**NEW YORK STATE THRUWAY AUTHORITY
DEPARTMENT OF ENGINEERING**

**AMENDMENT NO. 1
TO**

**CONTRACT TAS 24-20B
D214978
REPLACEMENT OF THE I-90 BRIDGE OVER
ORISKANY BOULEVARD (NY 69) AT MILEPOST 238.22
IN THE SYRACUSE DIVISION
OF THE NEW YORK STATE THRUWAY
IN ONEIDA COUNTY**

**IN THE LETTING OF
MAY 29, 2024**

TITLE OF PROJECT REPLACEMENT OF I-90 BRIDGE OVER ORISKANY BOULEVARD	CONTRACT NUMBER: TAS 24-20B
LOCATION OF PROJECT SYRACUSE DIVISION MP 238.22	DATE: 04/03/2024
TITLE OF DRAWING APPROACH TRANSITION RAILING DETAILS (1 OF 2)	DRAWING NUMBER: ST-53

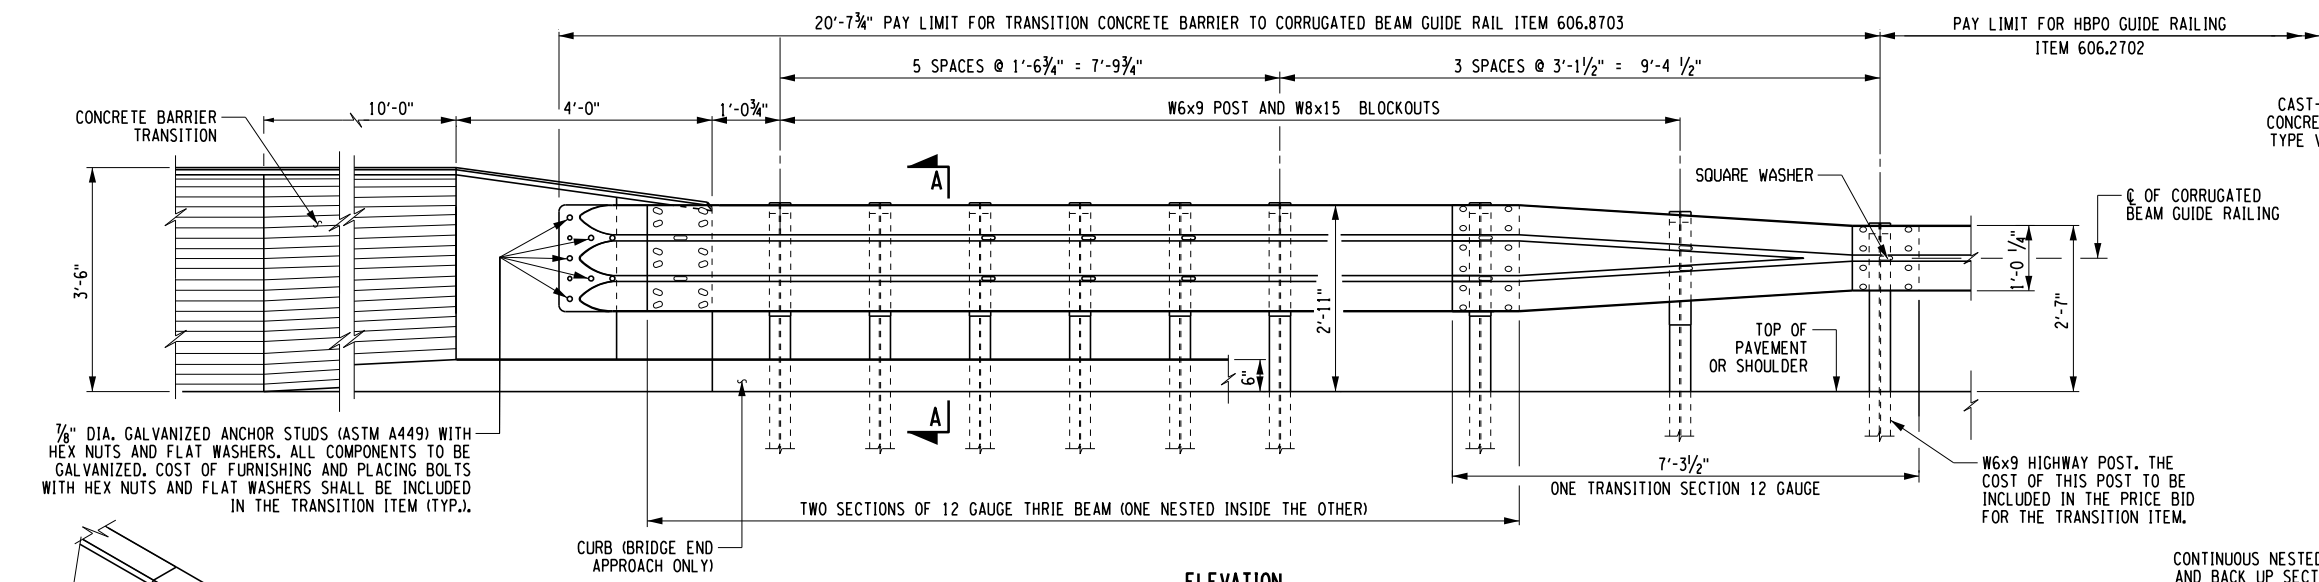
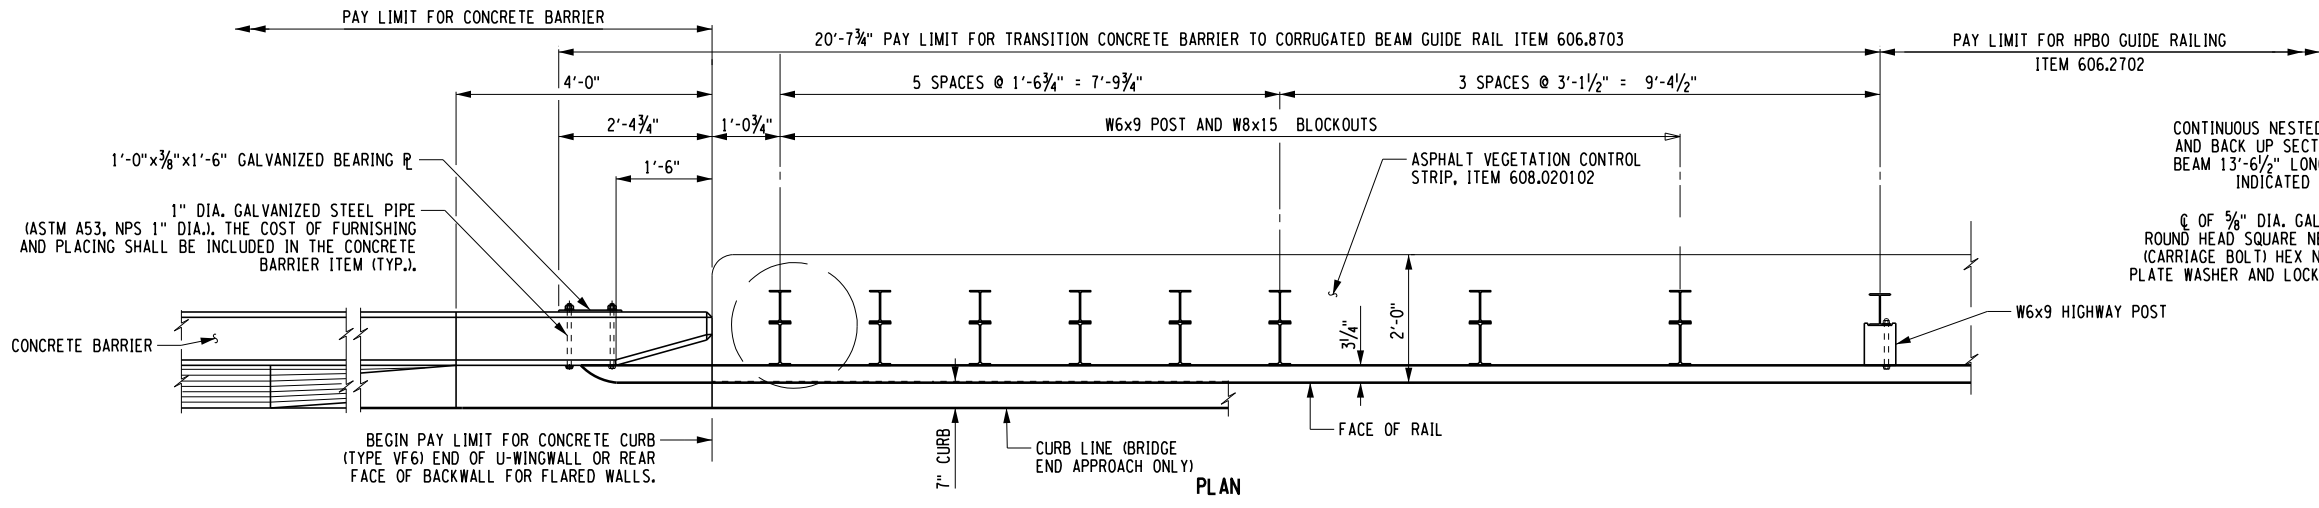
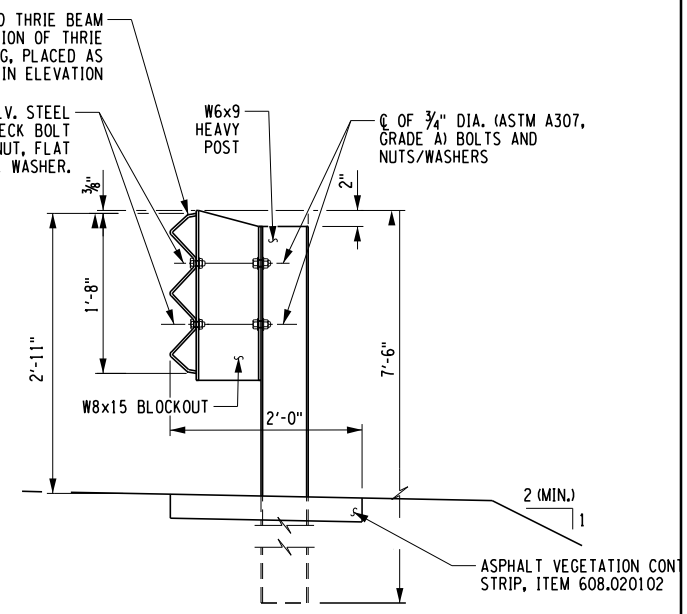
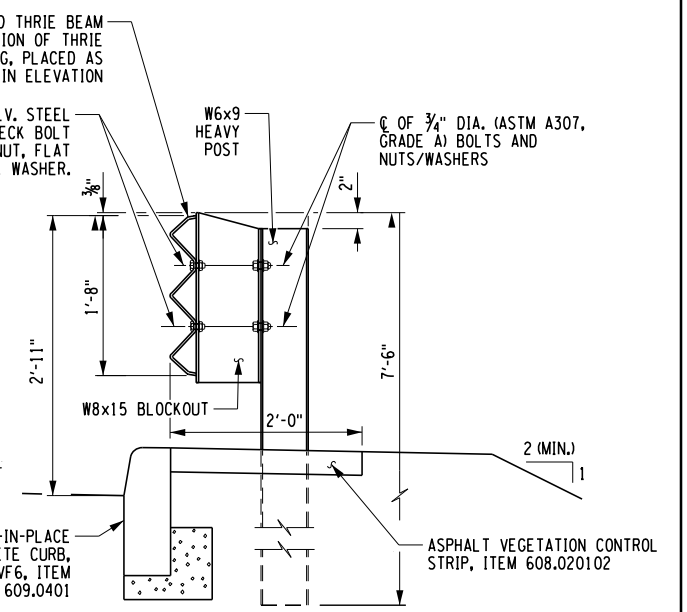
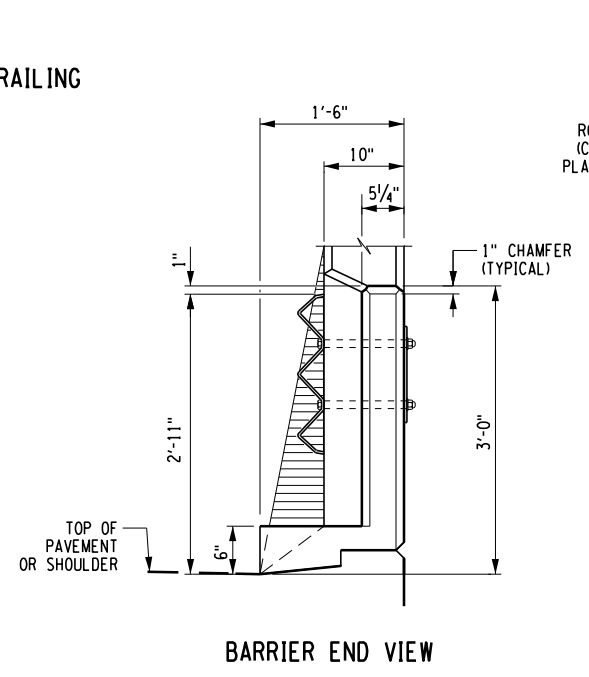
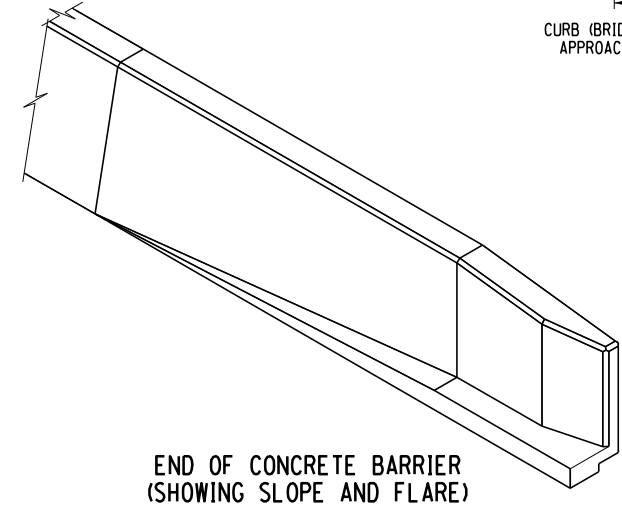
6. **DELETE** Drawing ST-53, Sheet 112, and **SUBSTITUTE** with the attached Drawing ST-53, Sheet 112A1. The Barrier End View was revised to include the bearing plate on the back side of the barrier shown and labeled in the plan view.
